**RE: MP 07_0010 – Environmental Assessment for Concept Plan and Stage 1 Project Application
Lot 4 DP 615261, Lot 1 DP 374315 and Part Crown Reserves R.82555 + R.754444, Ocean Drive Lake Cathie**

**RE: MP 07_0010 - ENVIRONMENTAL ASSESSMENT FOR CONCEPT PLAN AND
STAGE 1 PROJECT APPLICATION
LOT 4 DP 615261, LOT 1 DP 374315 AND PART CROWN RESERVES
R.82555 & R.754444, OCEAN DRIVE, LAKE CATHIE**

PROJECT NO:	4898	DRAWING TITLE:	EXHIBIT 06E - WESTERN BOUNDARY EDGE TREATMENT		
DA NO.:		PROJECT:	PART 3A CONCEPT PLAN APPLICATION LOT 1 DP374315 AND LOT 4 DP615261 OCEAN DRIVE, LAKE CATHIE		
DESIGNED BY:	AJT	CLIENT:	MILLAND PTY LTD & SEAWIDE PTY LTD	DRAWING NO:	4898P_WesternEEC
DRAWN BY:	MW			SHEET:	1
CHECKED BY:	AJT			REVISION:	C
DATE CREATED:	APRIL 2011

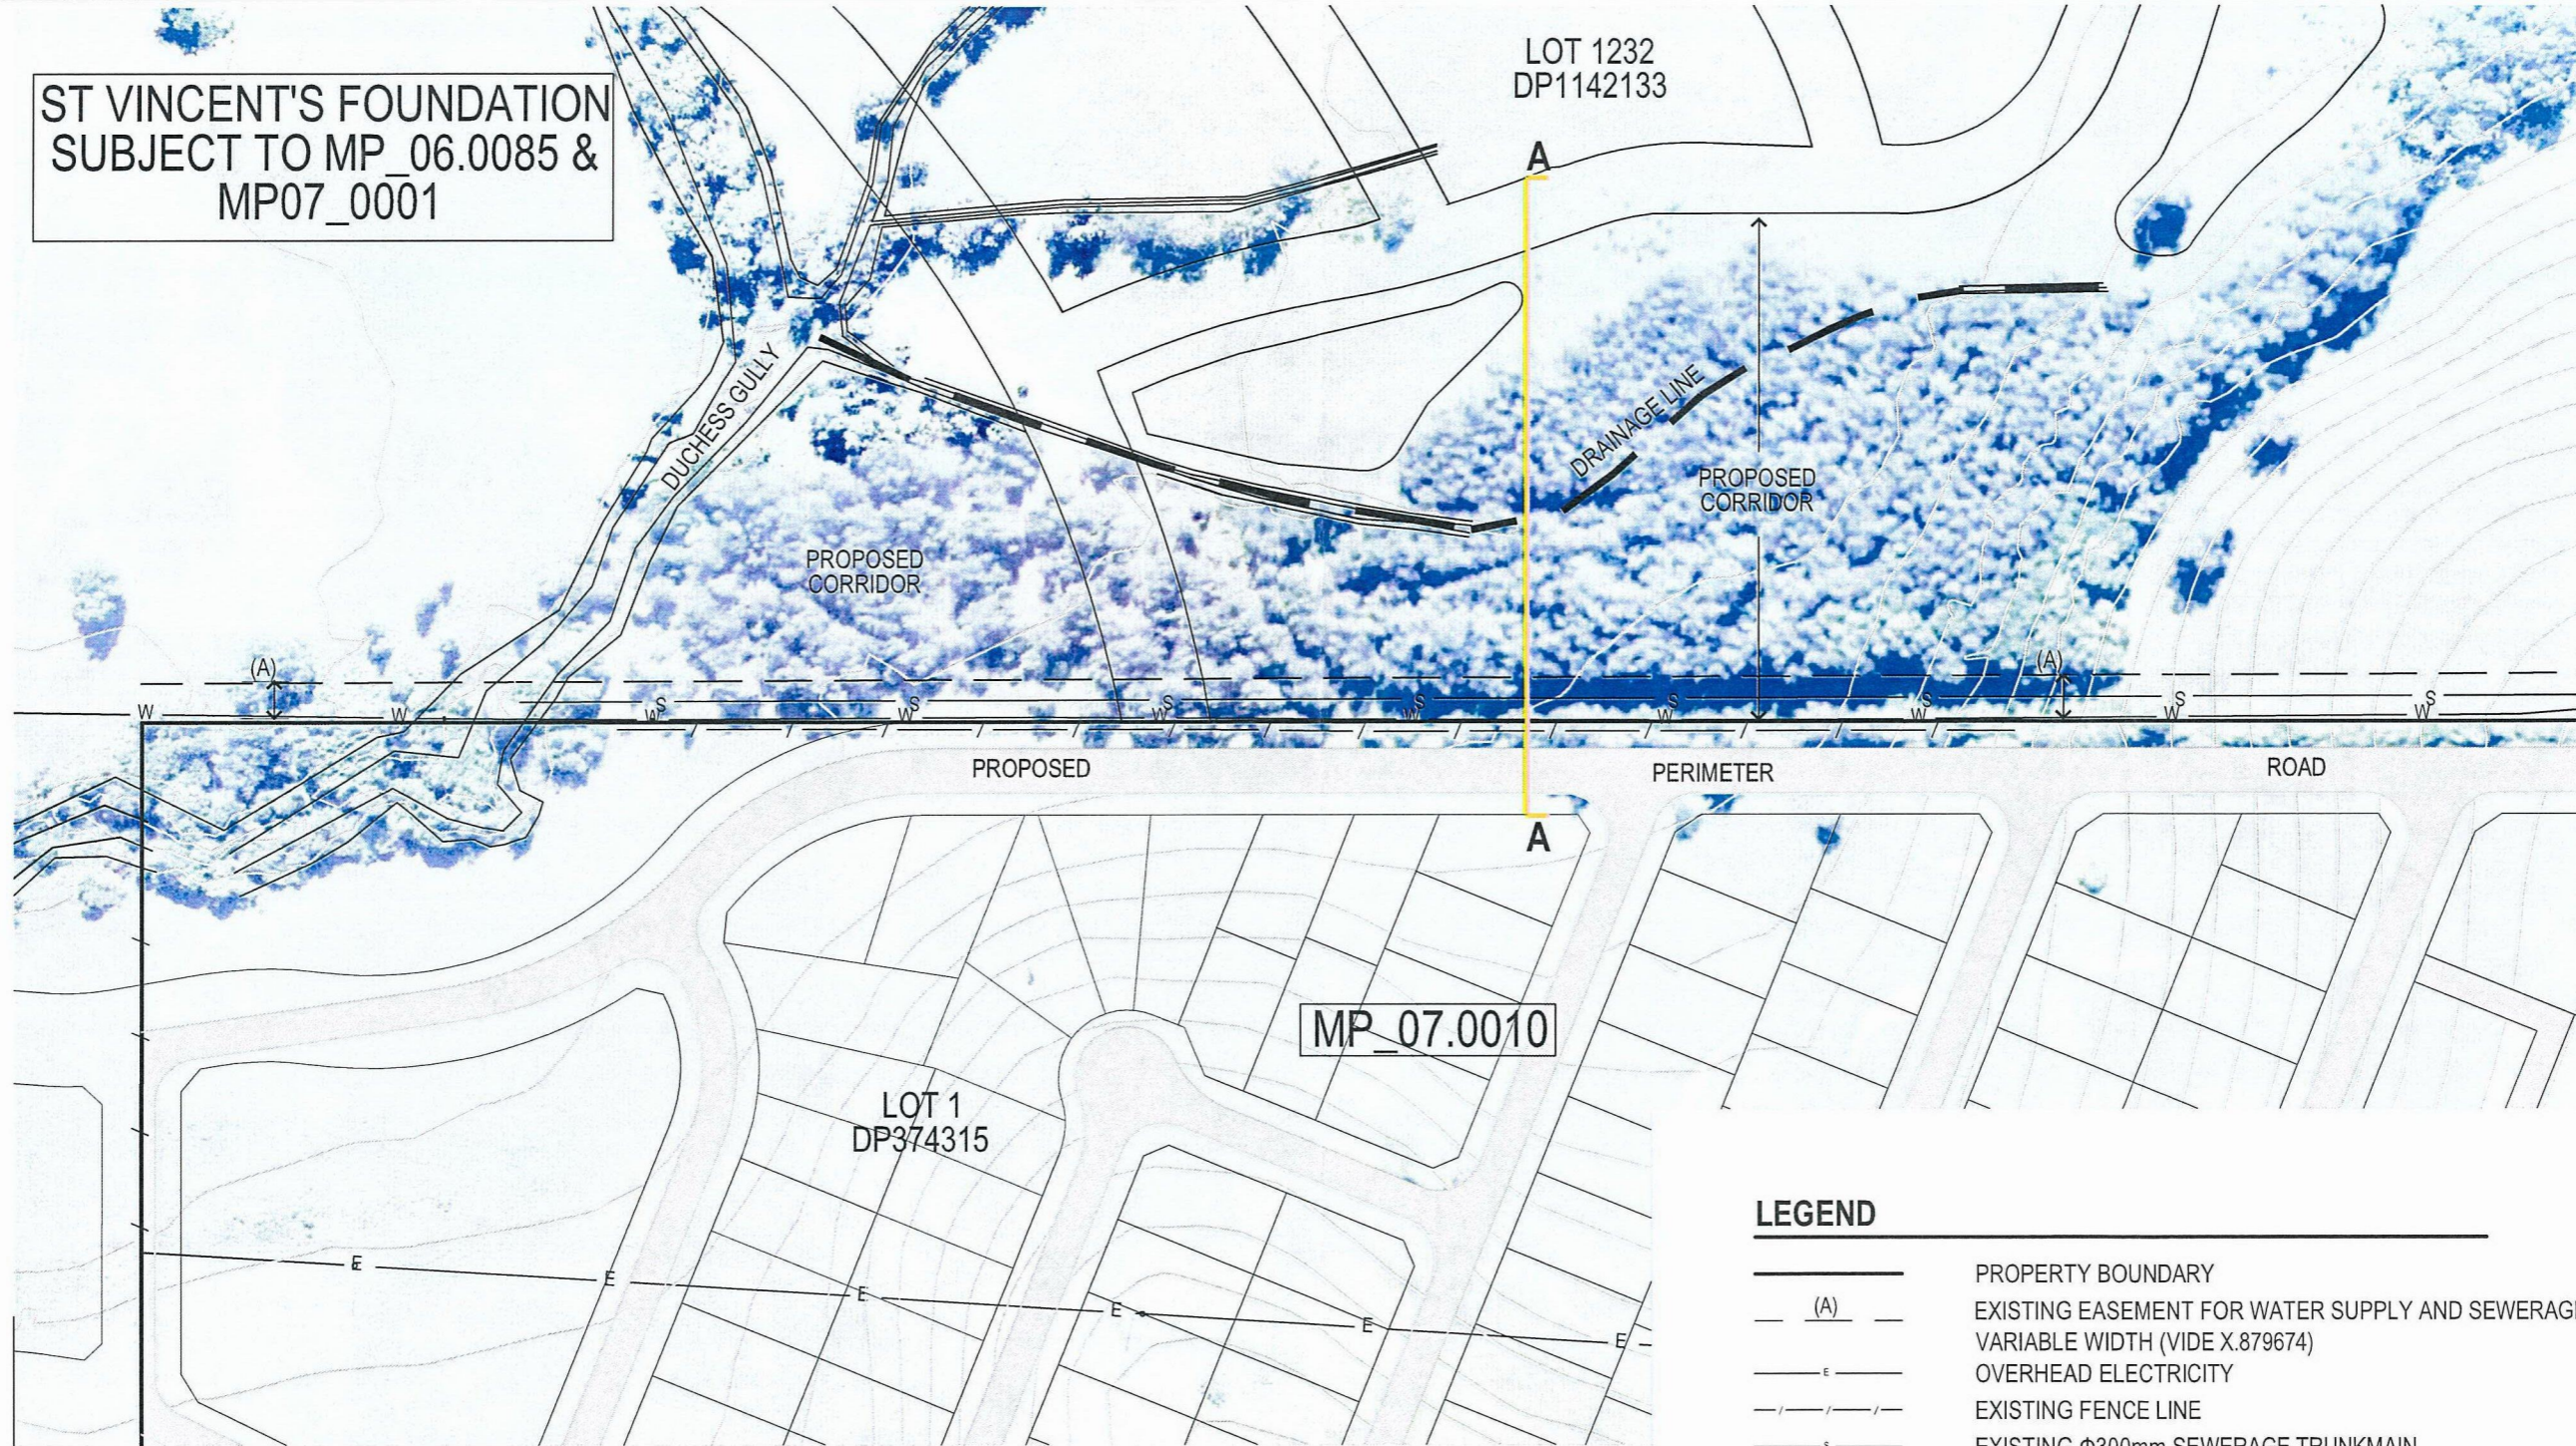
- Copy of the Plan (**Exhibit 06E rev.C**) and Cross-Section (**Exhibit 06F rev.B**) of the proposed Western boundary edge treatment adjoining the existing easement and swamp oak forest on the adjoining SVF land that were forwarded to Biolink Pty Ltd on 29 April, 2011.

- Biolink agree with PMHC that the Water Supply and Sewerage Easement approximately 9m wide effectively undermine the merit of an ecological buffer to the swamp oak forest;

- Biolink's preference is that from the western edge of the easement and for a distance of some metres into the swamp oak forest, dense plantings of *Lomandra* and *Gahnia* are established;

- Amended **Exhibit O8A rev.G** – 'Stormwater Concept Plan'; and
- New **Exhibit 06E rev.C** and **Exhibit 06F rev.B** in relation to the western boundary edge treatment.

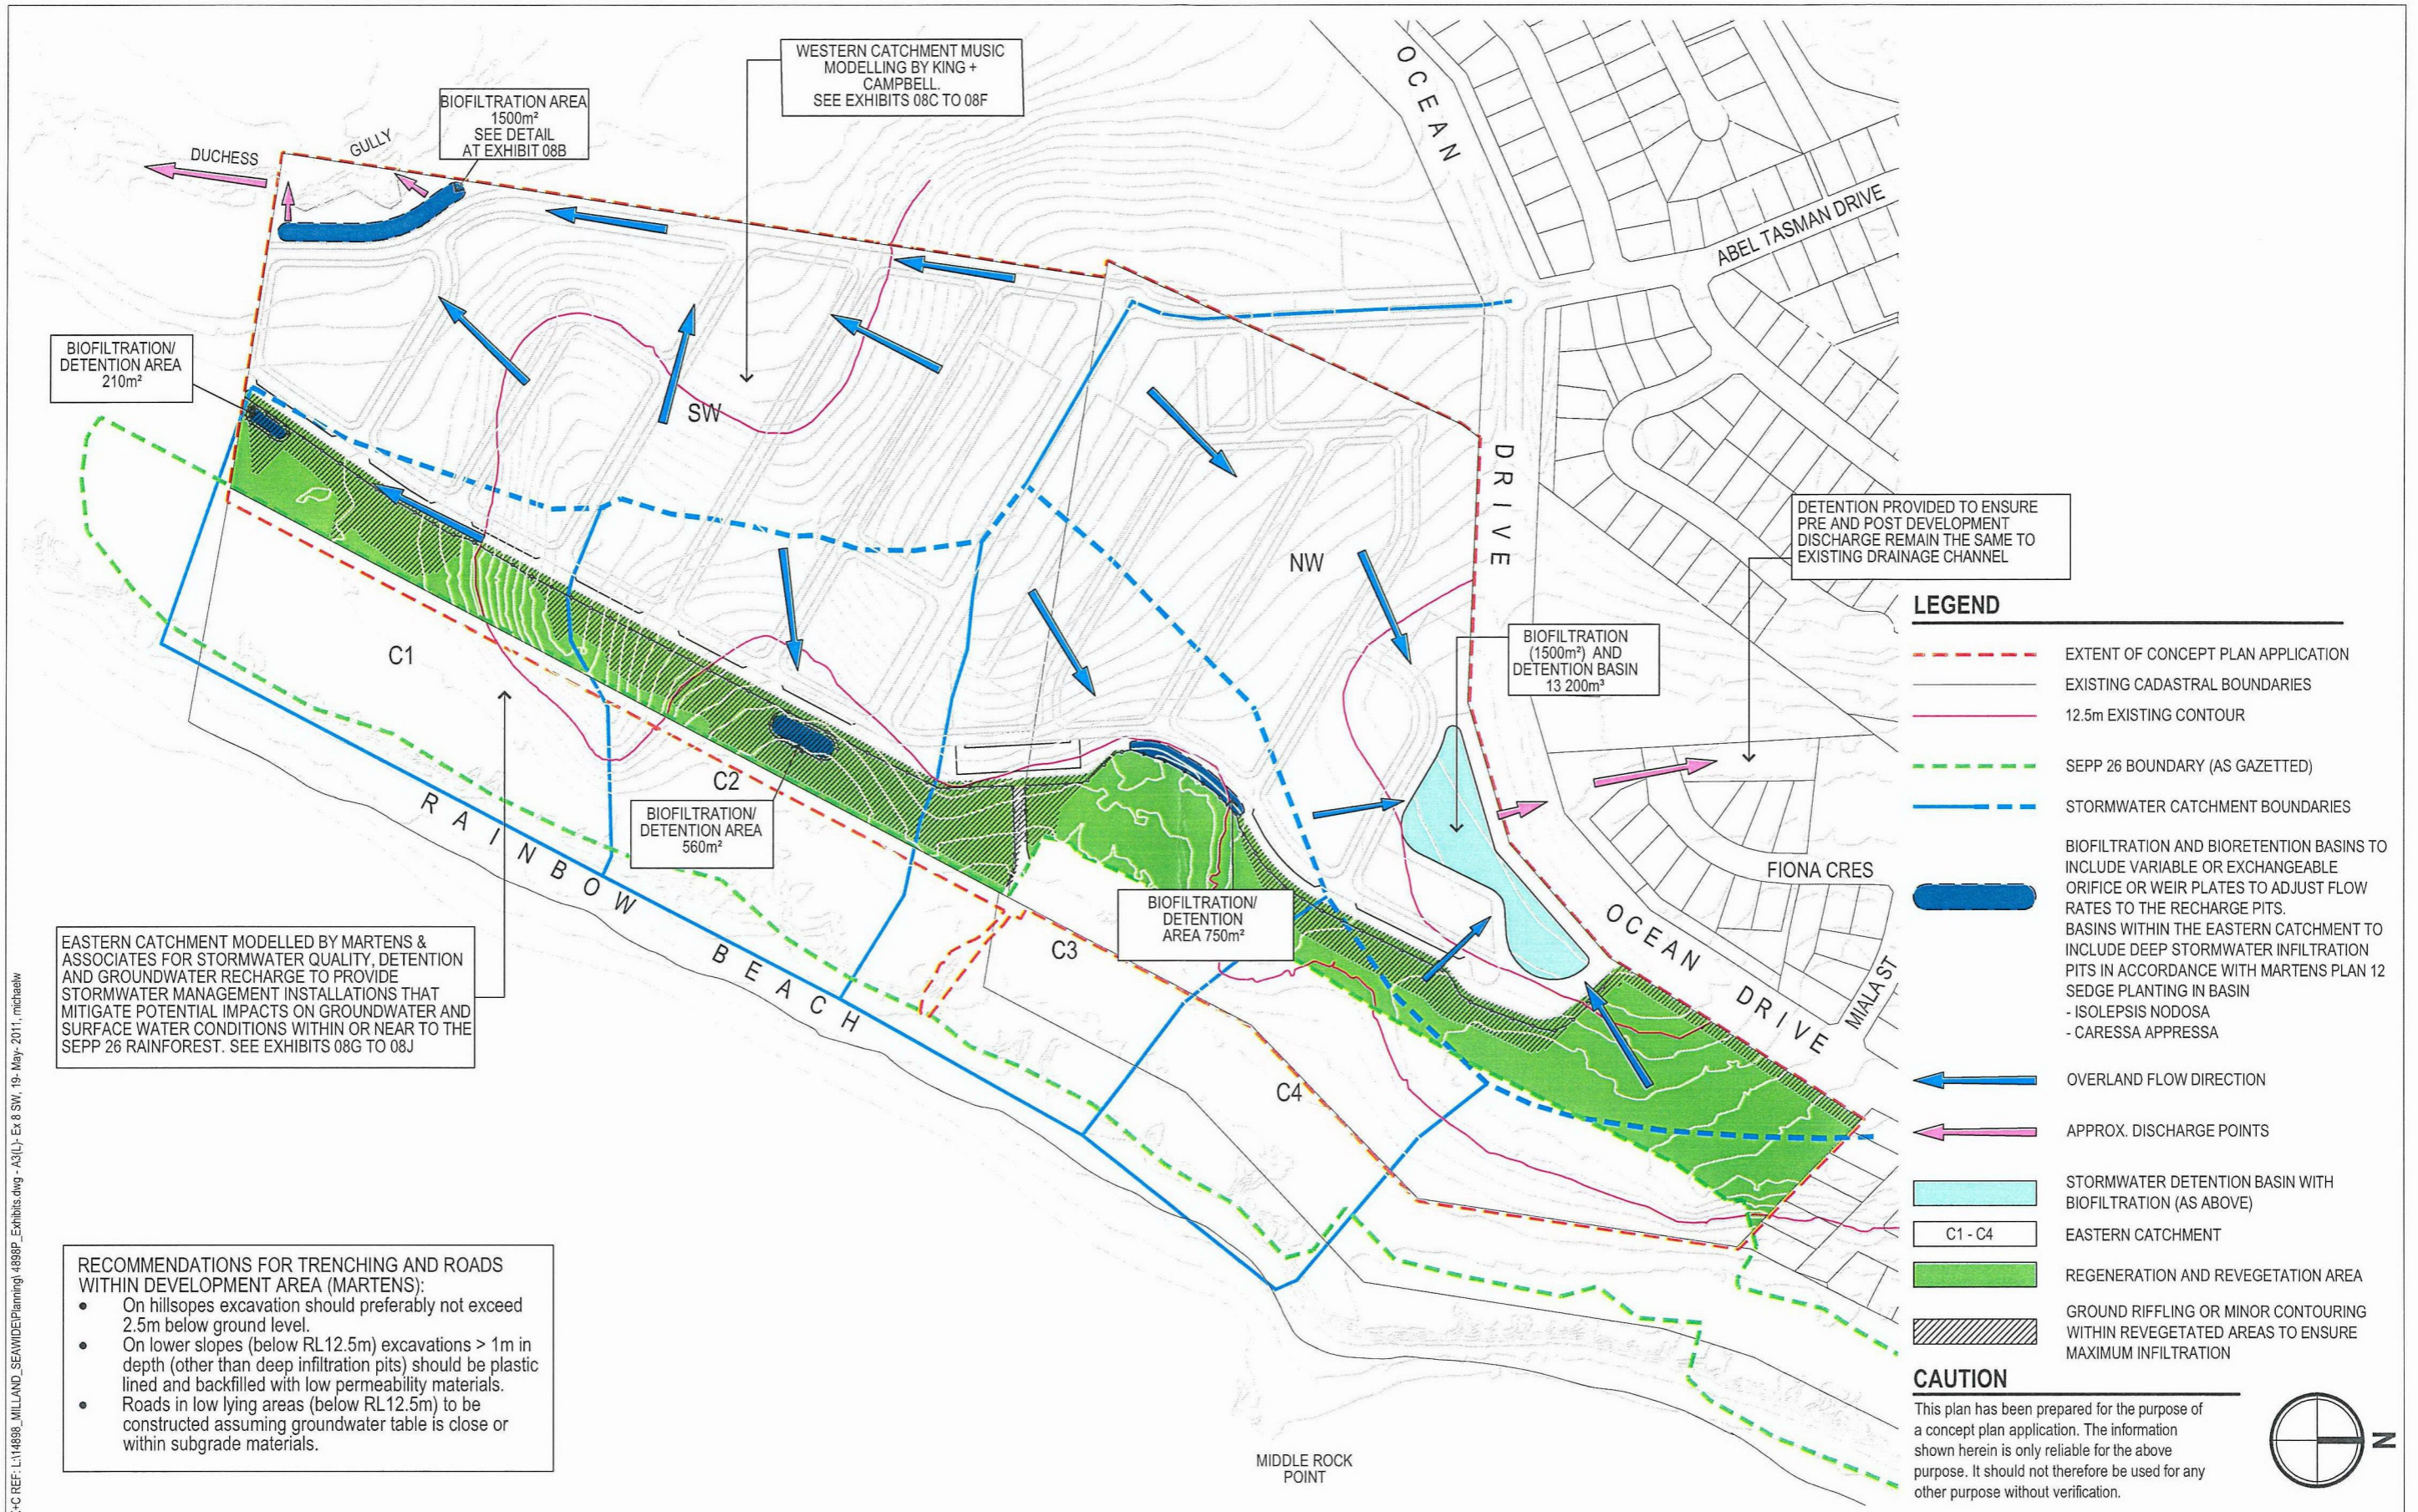
The project was modelled using MUSIC (Model for Urban Stormwater Improvement Conceptualisation) and the graphical representation of the MUSIC model (as included in the Environmental Assessment) is attached here for clarity (**Exhibit 08C, rev.C**). The Stormwater Concept Plan (**Exhibit 08A, rev.G**) has also been included to show the catchments, the detention and biofiltration locations and to correct an error in the north-western (NW) biofiltration basin. The biofiltration area for the NW catchment shown on Exhibit 08A has been amended to 1500m², and will be located within the stormwater detention basin. The overall footprint of the stormwater facilities in this location has not changed, nor has the data within MUSIC or DRAINS models.
